Increased Enrichment of Conventional and Accident Tolerant Fuel Designs for Light-Water Reactors

OG-24-15

Subject: PWR Owners Group
PWROG Comments on the Regulatory Basis Supporting Increased Enrichment of Conventional and Accident Tolerant Fuel Designs for Light-Water Reactors, 88 FR 61986; Docket ID NRC-2020-0034

Figure 1: Potential Control Room Dose Limit (Red)

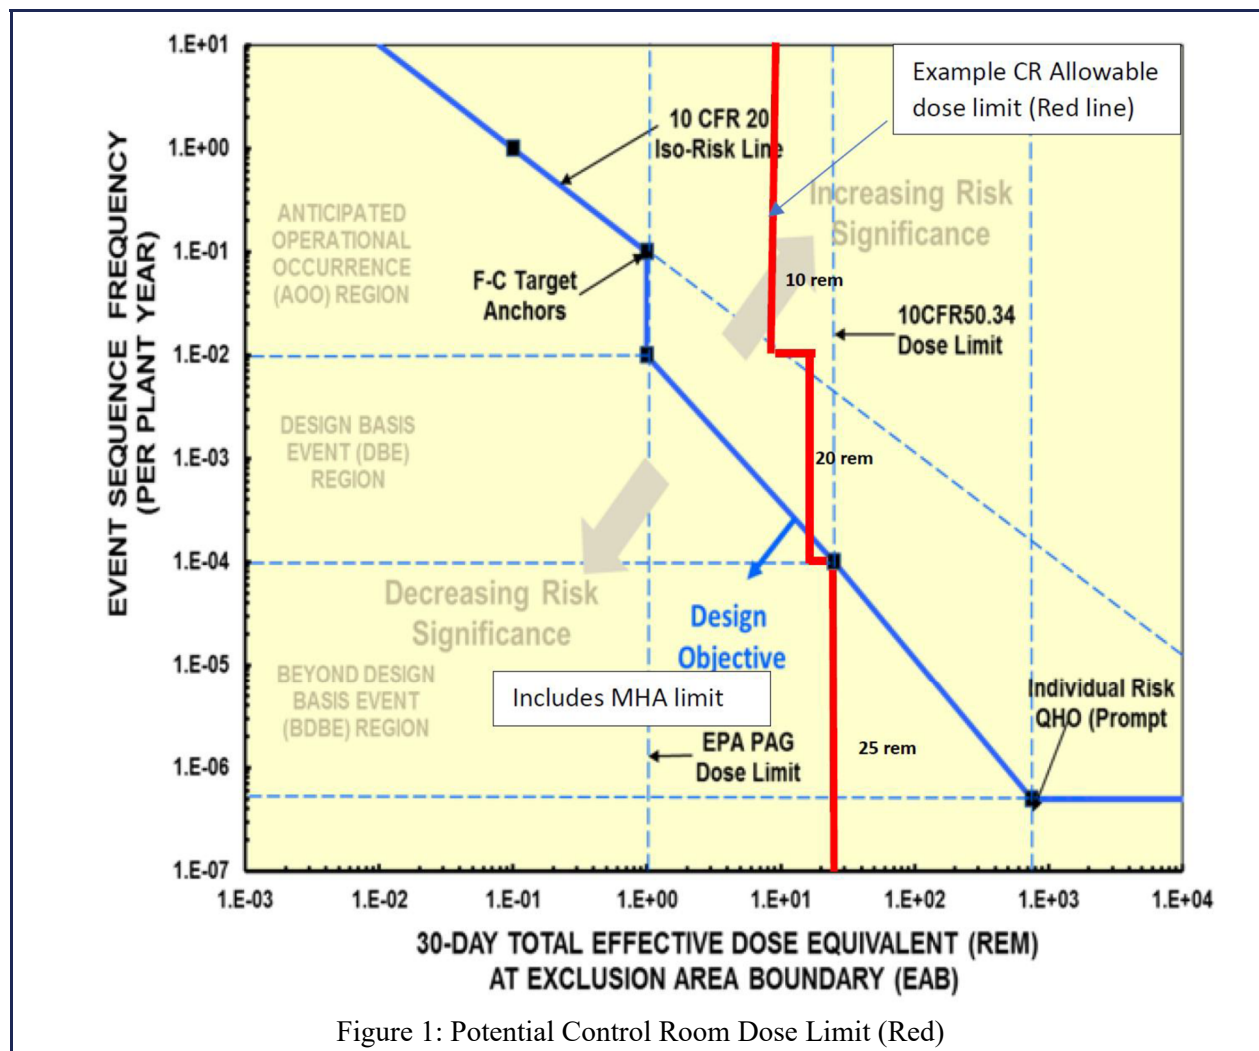
In the spirit of establishing a more risk-informed approach to control room dose limits, the NRC could structure the allowable control room dose along the lines of that proposed in NEI 18-04 using a frequency-consequence map (see Figure 1). A number of future nuclear technologies are planning to use the framework and construct of the Licensing Modernization Process (LMP) in NEI 18-04 which is endorsed by the NRC in RG 1.233. In the LMP context, the dose limits are risk informed based on the frequency and consequence of the likely challenges. A simplified application of that process to control room dose limits is presented in Figure 1, where a red line, representing a frequency-consequence (F-C) map for the control room (CR), is superimposed on the NEI 18-04 F-C map. In this illustration, events with higher frequencies and lower consequences, such as anticipated operational releases, [uncomplicated steam generator releases], could have allowable dose limits maintained at 10 rem (frequency $< \sim 10^{-3}$ /year), typical design basis transients with significant clad rupture (e.g., LOCAs) have estimated occurrence frequencies on the order of 10^{-4} /year (as illustrated in the figure), could have allowable dose limits raised to 20 rem and the maximum hypothetical accident (MHA) involving a partial core melt would have a frequency less than $\sim 10^{-5}$ /year the allowable dose could be raised to 25 rem. The intent of this approach is for the frequencies associated with individual scenarios (e.g., initiating event frequencies, consequential failure probabilities and component/recovery unavailability/failures) to be plant-specific and consistent, where applicable, to the accepted values used in the PRA. This graded approach provides flexibility in design and ensures a high level of protection commensurate with the nature of the challenge. However, tiered limits may require an additional step of binning challenges based on frequency and potentially may complicate the analysis.

The control room design criteria should be graded, with a risk-informed method based on event frequency, to demonstrate compliance with a range of acceptable control room design criterion values, with a single selected value representing a maximum dose criterion for events of the lowest frequency. This provides the necessary flexibilities for current and future nuclear technologies.

Figure 2: Control Room dose (no frequency) for **LOCA**, **SGTR** and **LOAC**

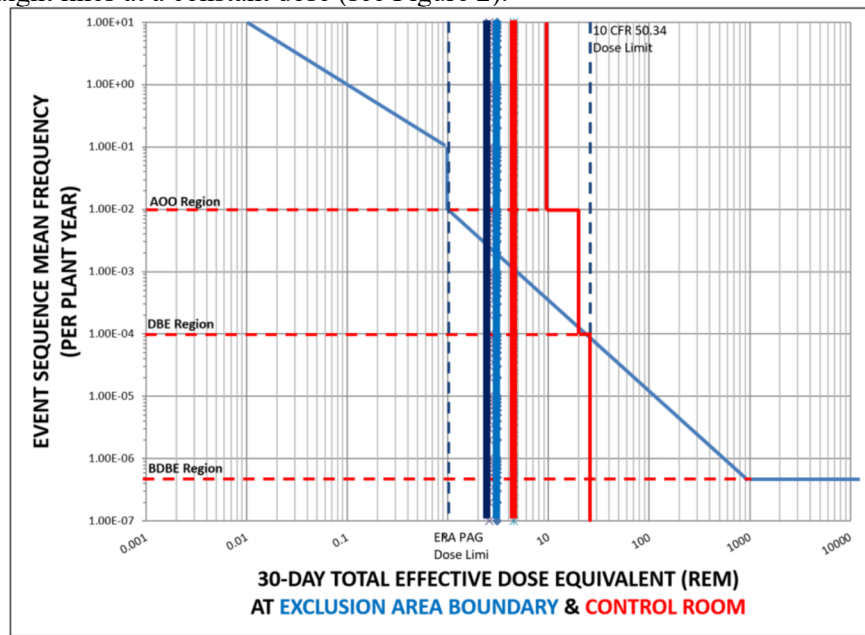
Plotting the estimated CR dose in the consequence vs. frequency space discussed above in Figure 1 (note that the EAB thresholds from the LMP are also provided for reference), the above results are essentially straight lines at a constant dose (see Figure 2).

Figure 3: Control Room dose (with frequency estimate) for LOCA, SGTR and LOAC

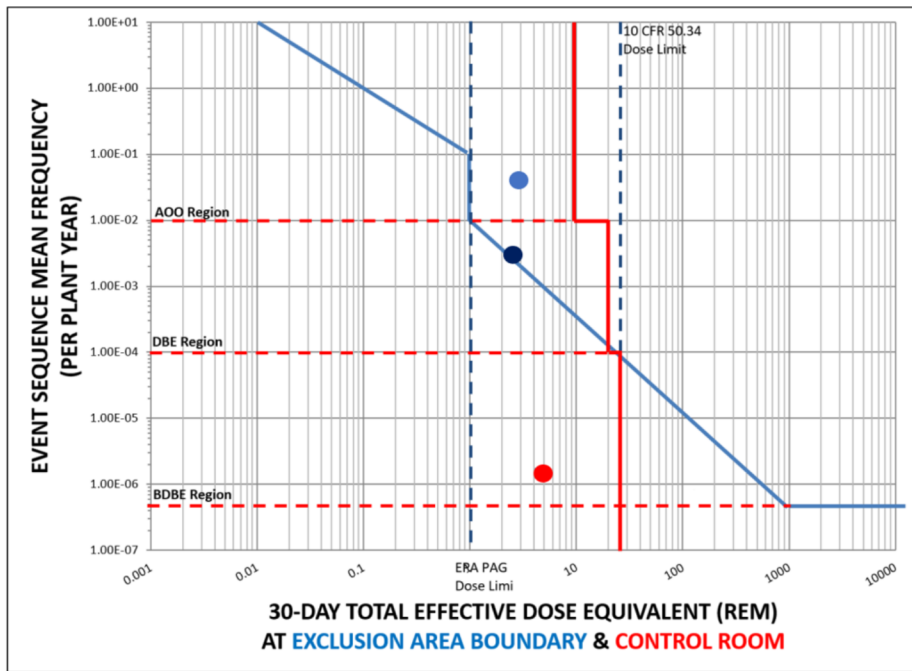
Figure 3 provides a plot of representative calculated CR doses for radiological release scenarios associated with various initiating events. A rough estimate of the frequency of the scenarios was performed by simply assigning the generic initiating event frequency (IEF) normally used in the PRA for Large LOCA, SGTR and LOOP (from NUREG-CR/6928) to the design basis control room dose associated with that initiating event. This is considered to be a conservative estimate of the frequency of the specific scenario evaluated in the dose estimate because additional failures (e.g., concurrent LOOP, single failure, maximum TS conditions, etc...) have not been assessed for a realistic frequency estimate that would further reduce the design basis scenario frequencies plotted in Figure 3. The intent of this figure is to show the progressive margin towards the proposed thresholds. That margin is essential to accommodate the anticipated impacts from increased enrichment fuel management strategies which are the impetus for the proposed rulemaking.
